AGENDA ITEM SUMMARY / STAFF REPORT
FLORENCE PLANNING COMMISSION

ITEM NO: 4
Meeting Date: December 12, 2023

ITEM TITLE: PC 23 08 DR 02 – *Dollar General Design Review*

35th STREET (DELIVERY) - SOUTH

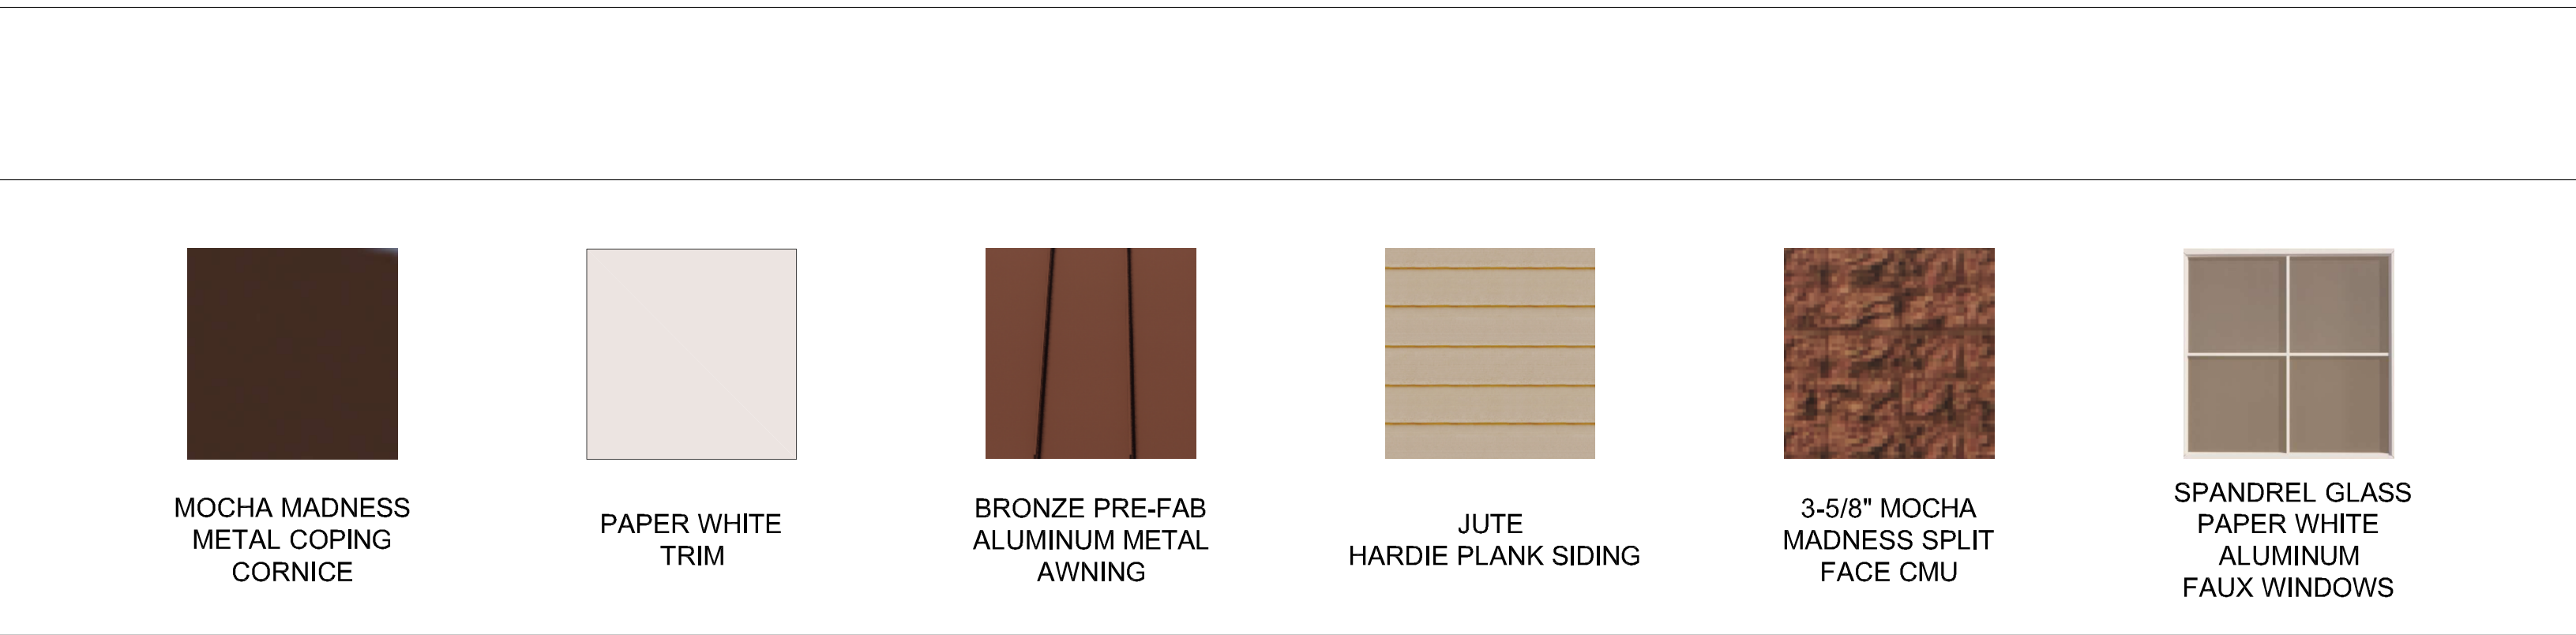
On December 4, the applicant provided revisions to Exhibit D, Elevations and Design. These revised sheets are included in Exhibit D1 and demonstrate a new vertical articulated design on and color element to the south side. With this submission, the applicant also demonstrates that the front entrance is now recessed 4' inward and provided the trim and gutter colors, which were other topics of concern during the hearing.

The subject of vertical and horizontal line elements was a key discussion during the November 14, 2023 public hearing. The Planning Commission stated that they wanted to see more of these design elements. In response, the applicant submitted Exhibit D1, a revision to Exhibit D. Sheet A-3 of Exhibit D1 now demonstrates a horizontal change in the south elevation roofline and vertical change in elevation through the addition of the color Mocha Madness. Additionally, the applicants provided evidence that the cornices would feature the same color.

DESIGNER:	A. VOS
DRAWN BY:	A. VOS
APPROVED BY:	J. GLANDER
DATE:	NOVEMBER 2023
JOB NO:	23-000186
DRAWING FILE NO:	22-000186-X-LS
DRAWING NO:	LS-01
SHEET NO:	1 OF 2

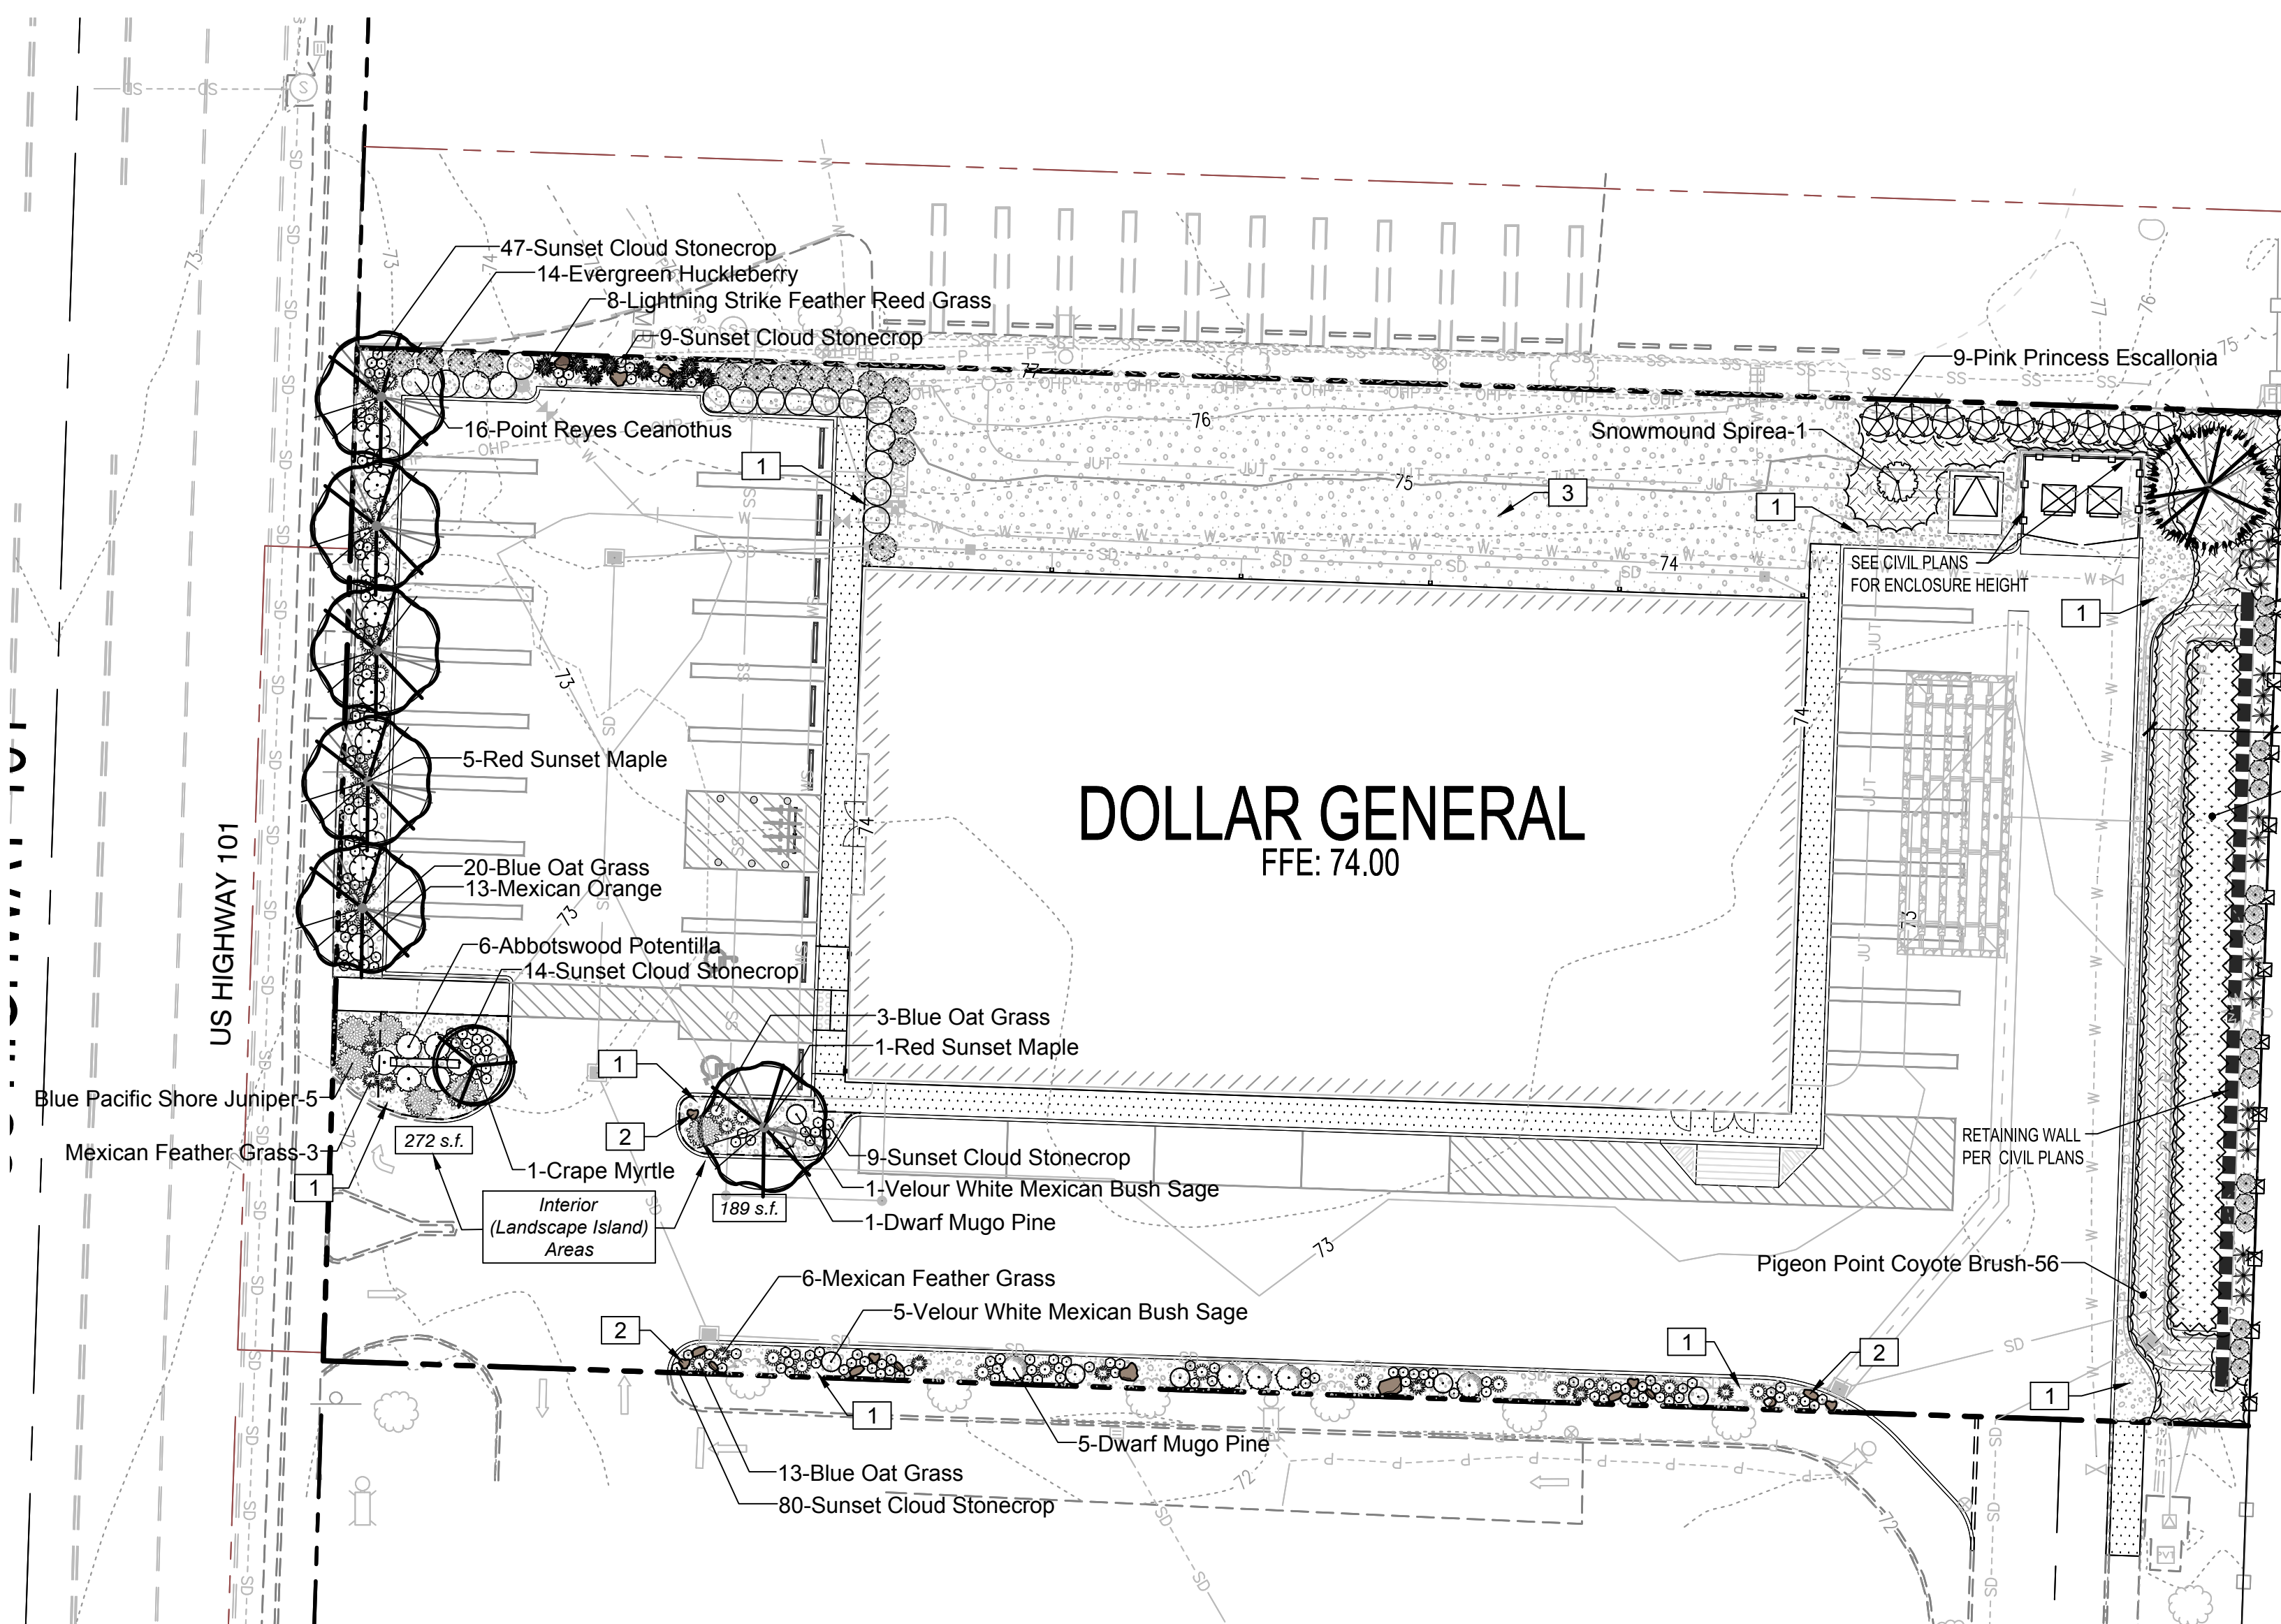
Condition 7-5: This condition required a minimum of one tree in each of the two parking lot landscaping islands. The applicant supplied the revised Landscape Plan (Exhibit E1, Sheet LS-01) which demonstrates the addition of a Red Sunset Maple tree in one island, which includes the rearrangement and more plantings than what was provided in Exhibit E, and a Crepe Myrtle tree in the other.

Condition 7-5 was proposed in the initial resolution. It read: ‘Parking islands are evenly distributed. The two parking islands located north of the Highway 101 driveway approach do not contain trees. Per FCC 10-34-3-6 B, the applicant shall provide a minimum of one tree selected from the Tree and Plant List for the city of Florence installed per island.’ The applicant supplied the revised Landscape Plan (Exhibit E1, Sheet LS-01) which demonstrates the addition of a Red Sunset Maple tree in one island, which includes the rearrangement and more plantings than what was provided in Exhibit E, and a Crepe Myrtle tree in the other which made Condition 7-5 unnecessary. Criterion met.
